To: T10 Committee (SCSI)

From: George Penokie (IBM/Tivoli)

Subject: SAS 1.1 - Transport layer retry and argument passing fixes

Figure 149 — ST_I (transport layer for SSP initiator ports) state machines

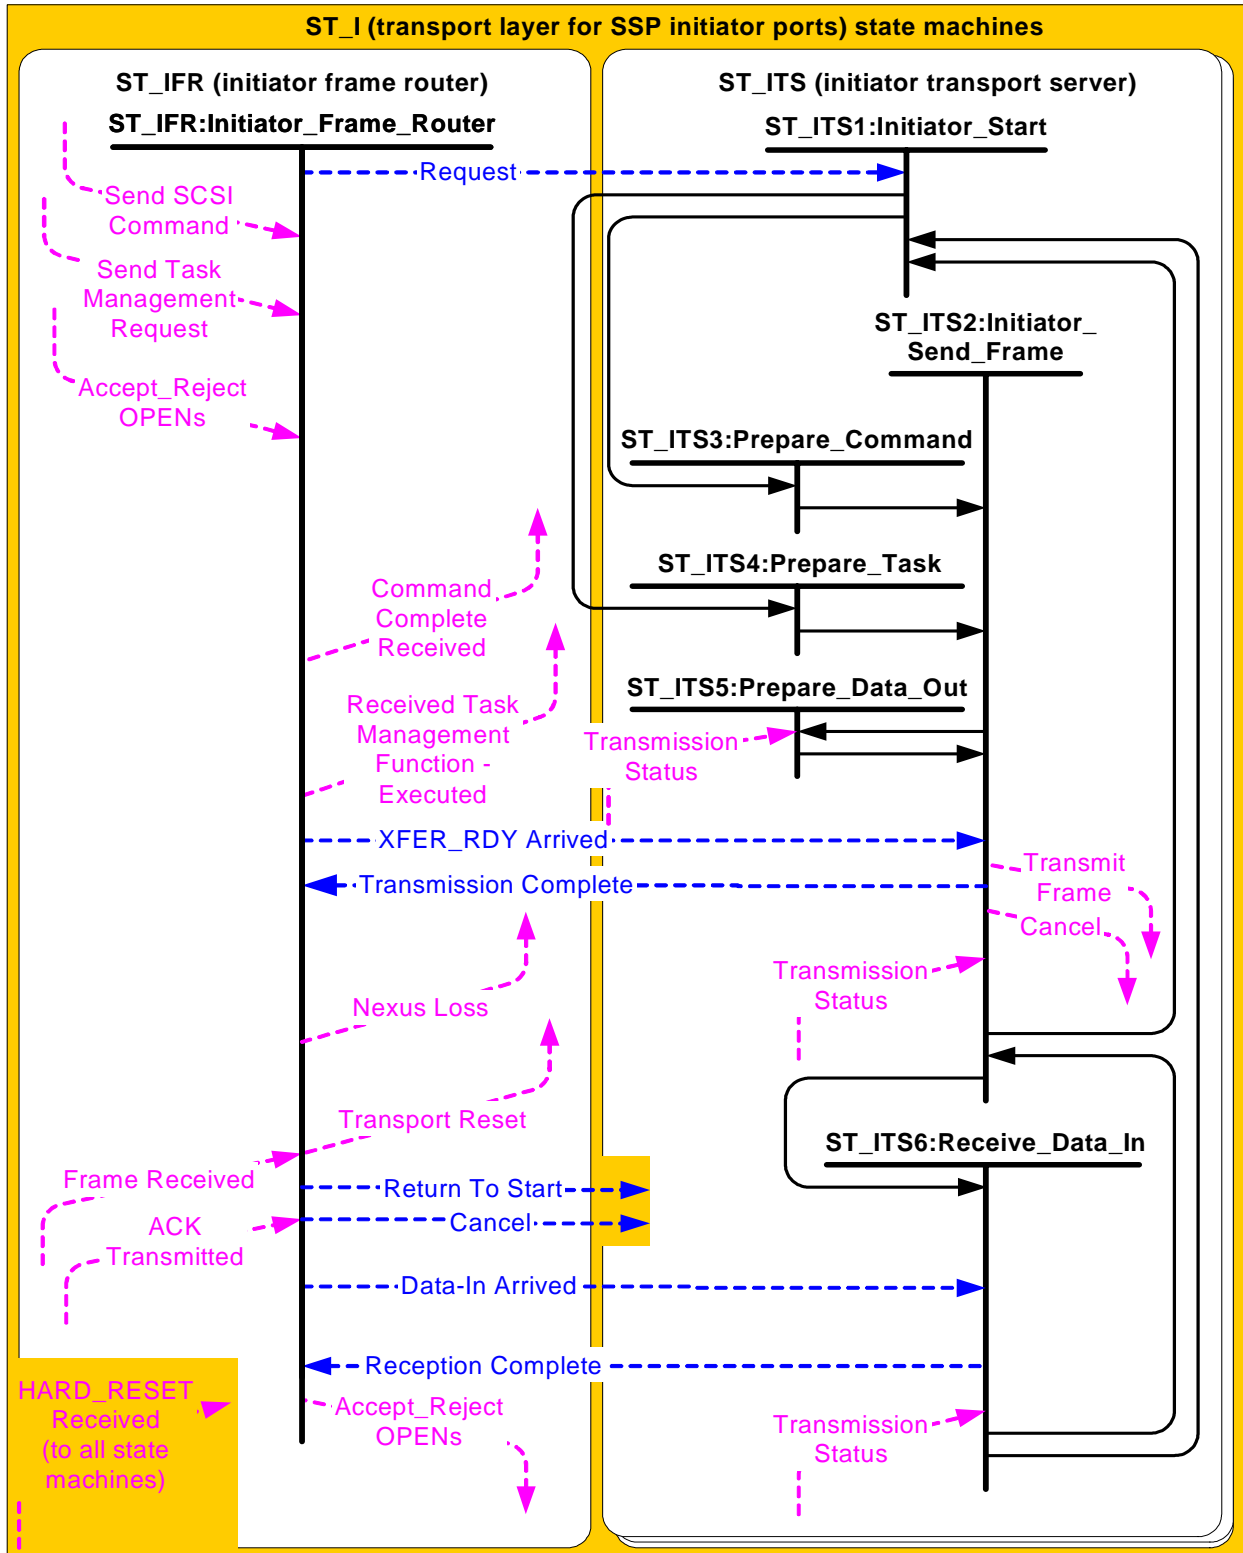
Editor's Note 14: Added Data-In Arrived message into ST_ITS7 and Transmission Status confirmation into ST_ITS5 to allow for non-interlocked DATA frame transfers. Changed Cancel

message to go to all states. Added a Return To Start message to all states. Deleted ST_ITS7. Added transition from ST_ITS1 to ST_ITS3 and ST_ITS4. Deleted transition from ST_ITS2 to ST_ITS3 and from ST_ITS2 to ST_ITS4.

Figure 150 — ST_T (transport layer for SSP target ports) state machines

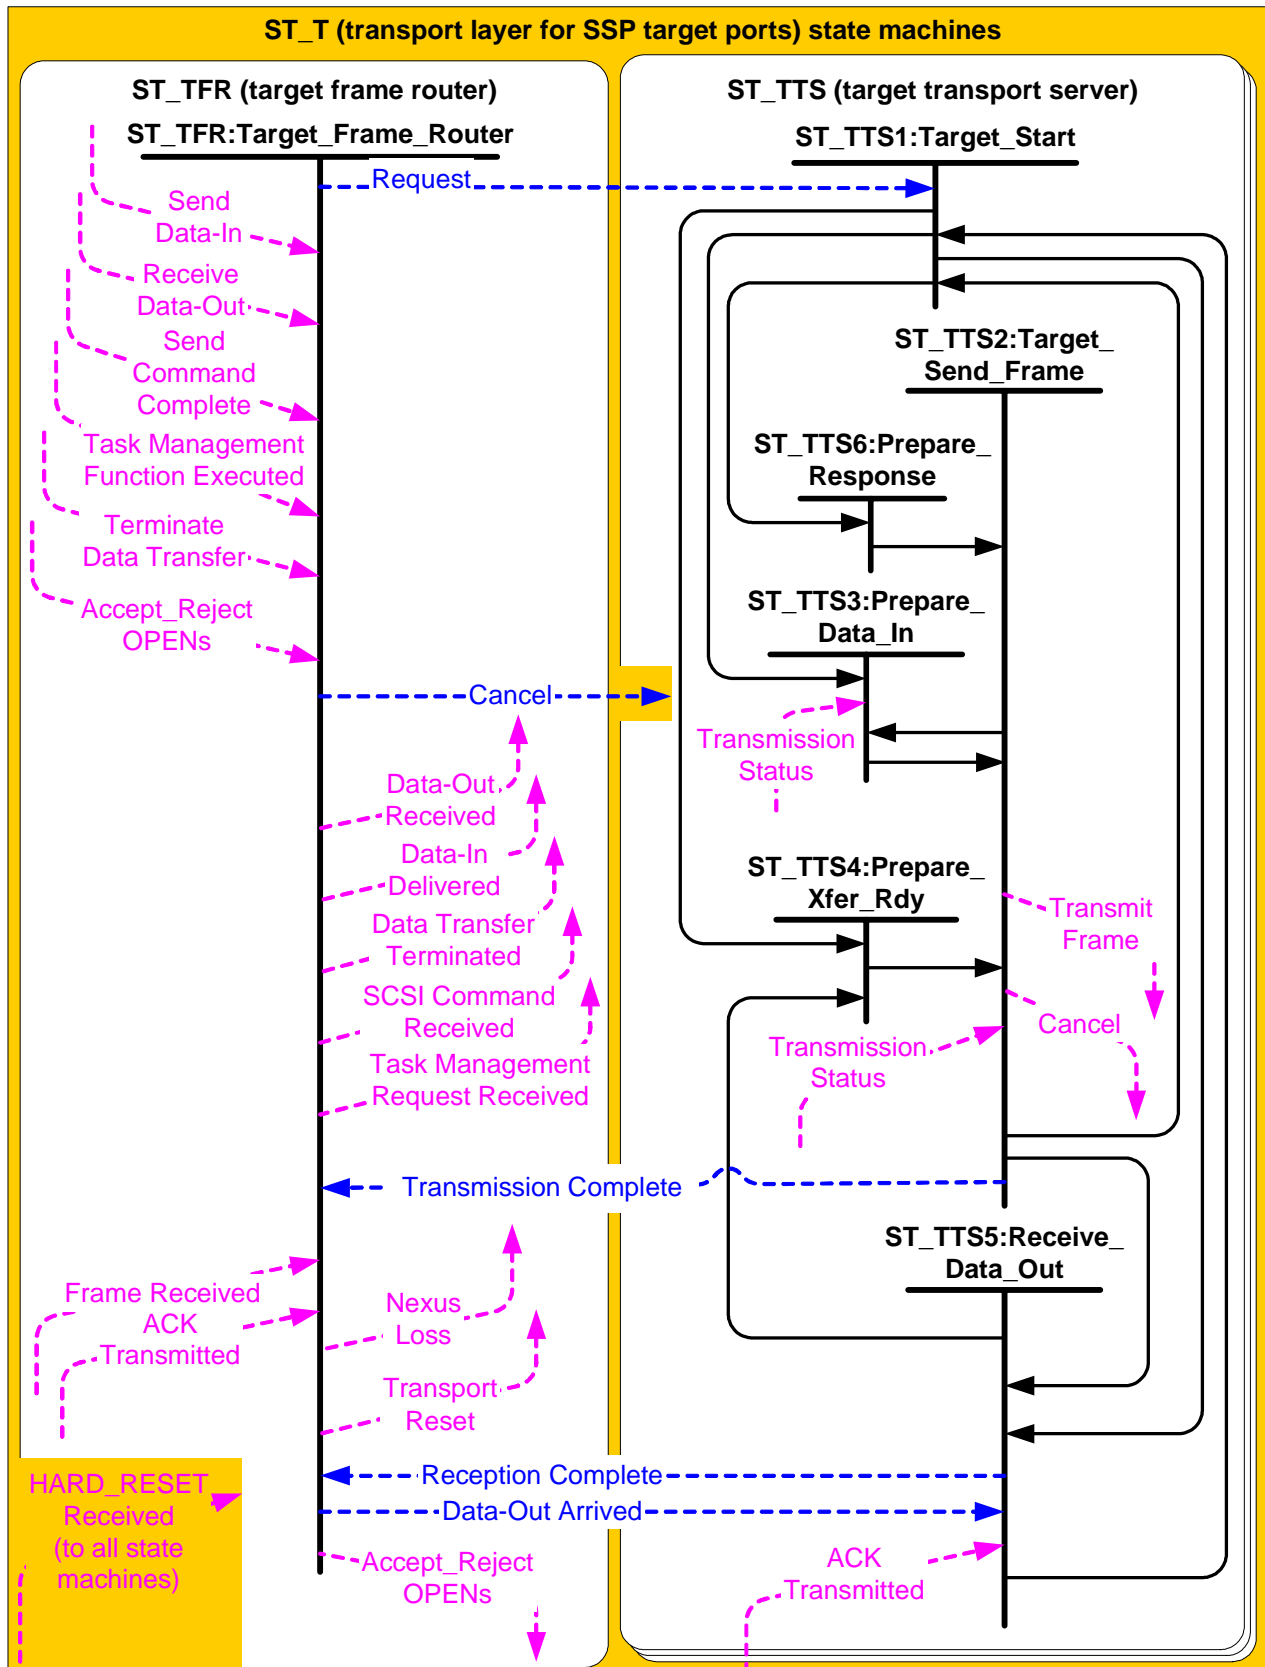
Editor's Note 15: Added Transmission Status confirmation into ST_TTS3 to allow for non-interlocked DATA frame transfers. Changed Cancel message to go to all states. Added ACK Transmitted to ST_TTS5. Deleted ST_TTS1 to ST_TTS2 transition, ST_TTS5 to ST_TTS2 transition, ST_TTS7 to ST_TTS2 transition, and ST_TTS4 to ST_TTS2 transition. Added ST_TTS1 to ST_TTS3 transition, ST_TTS1 to ST_TTS4 transition, ST_TTS1 to ST_TTS7 transition, and ST_TTS5 to ST_TTS4 transition. Change ST_TTS7 to ST_TTS6.

Figure 151 — ST_I (transport layer for SSP initiator ports) state machines

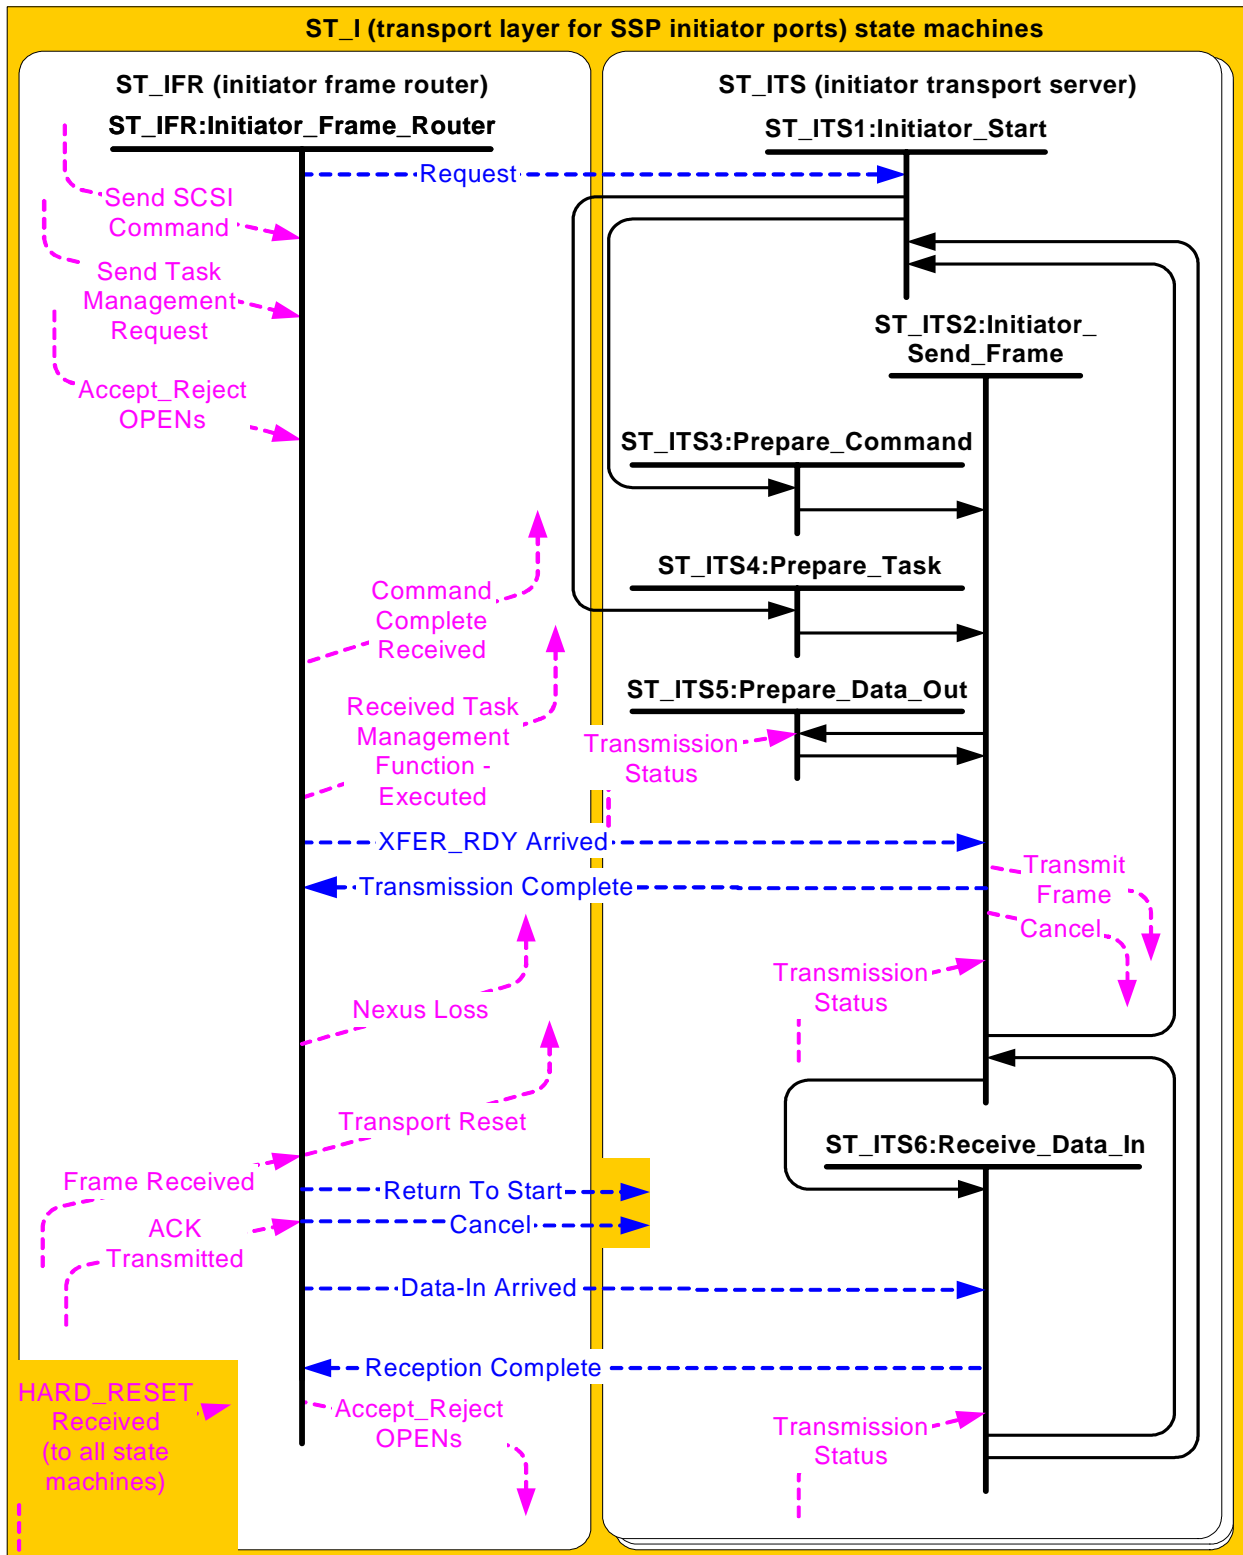
[Editor's Note 16: Added Data-In Arrived message into ST_ITS7 and Transmission Status](#)

[confirmation into ST ITS5 to allow for non-interlocked DATA frame transfers. Changed Cancel message to go to all states. Added a Return To Start message to all states. Deleted ST ITS7. Added transition from ST ITS1 to ST ITS3 and ST ITS4. Deleted transition from ST ITS2 to ST ITS3 and from ST ITS2 to ST ITS4.](#)

Figure 152 — ST_T (transport layer for SSP target ports) state machines

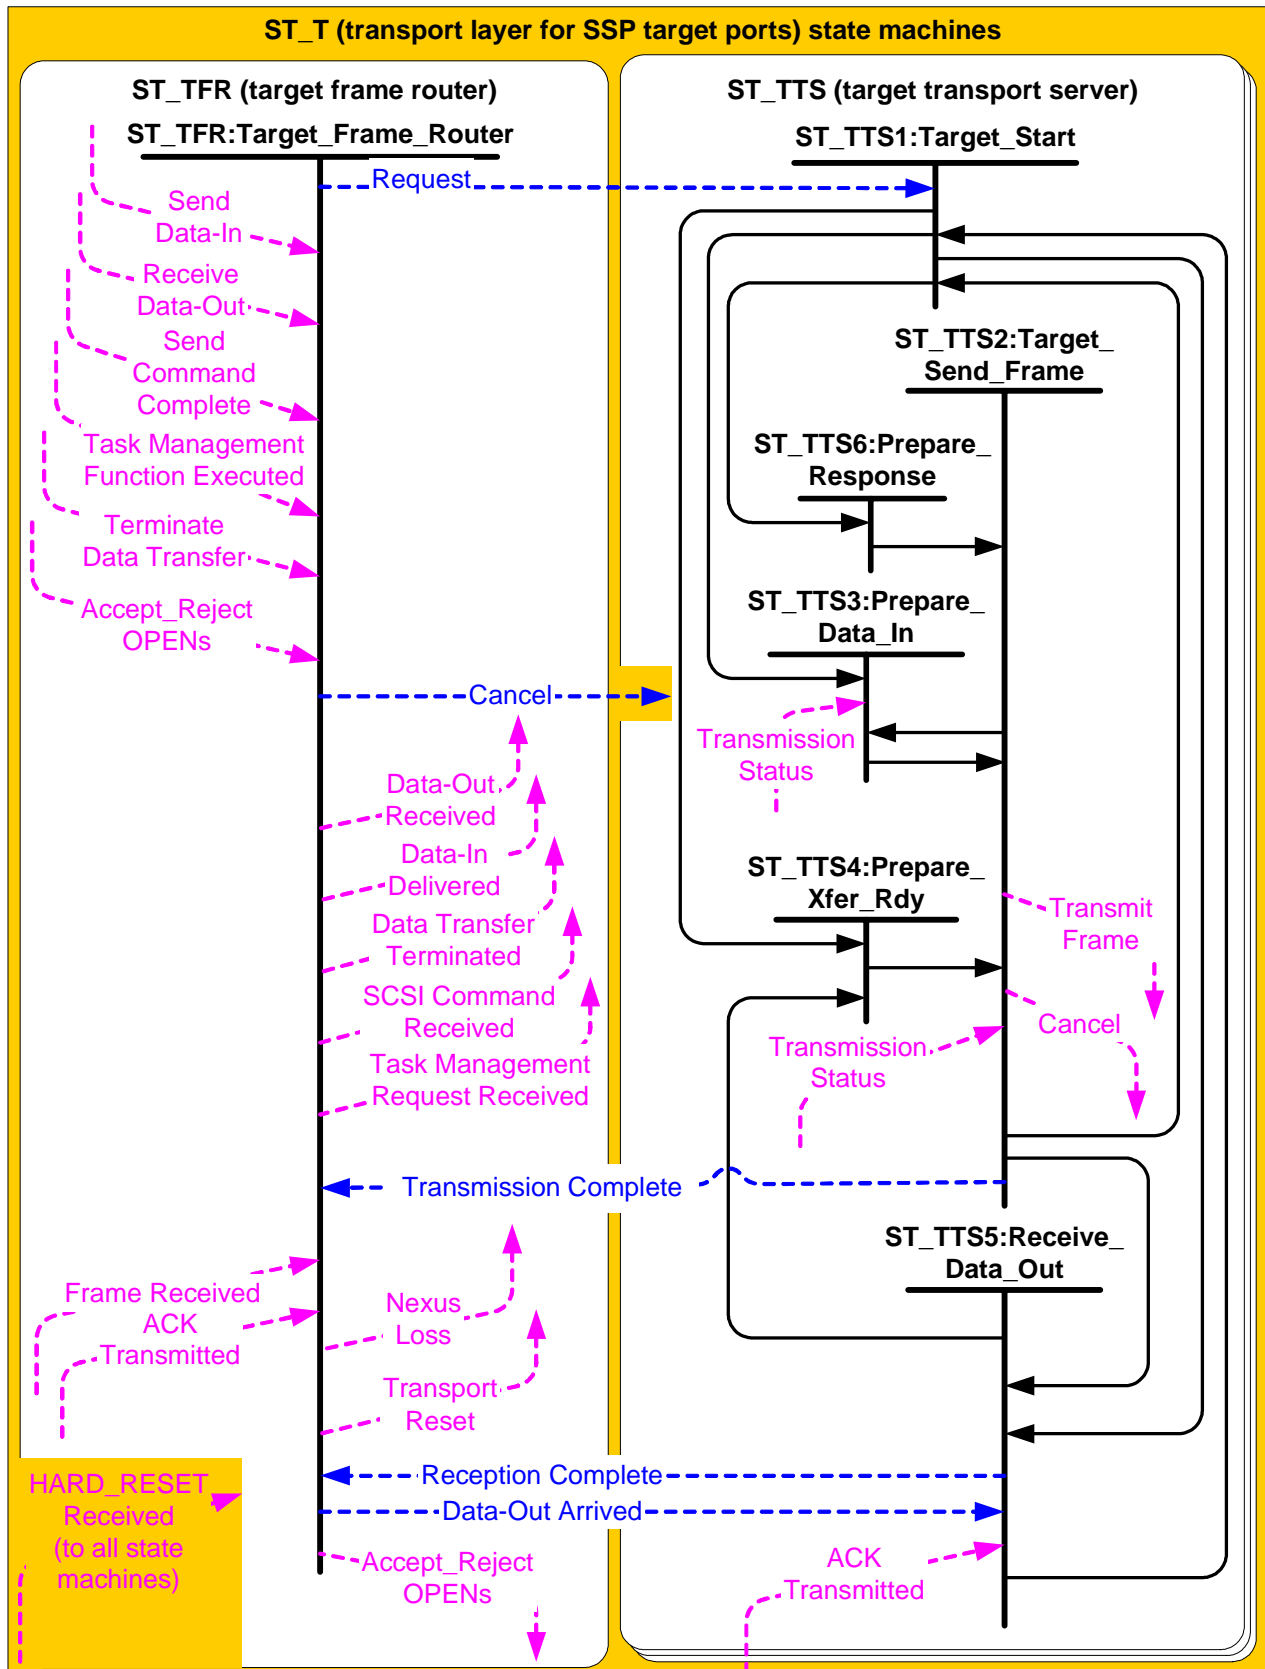
[Editor's Note 17: Added Transmission Status confirmation into ST_TTS3 to allow for non-interlocked DATA frame transfers. Changed Cancel message to go to all states. Added ACK Transmitted to ST_TTS5. Deleted ST_TTS1 to ST_TTS2 transition, ST_TTS5 to ST_TTS2 transition, ST_TTS7 to ST_TTS2 transition, and ST_TTS4 to ST_TTS2 transition. Added ST_TTS1 to ST_TTS3 transition, ST_TTS1 to ST_TTS4 transition, ST_TTS1 to ST_TTS7 transition, and ST_TTS5 to ST_TTS4 transition. Change ST_TTS7 to ST_TTS6.](#)
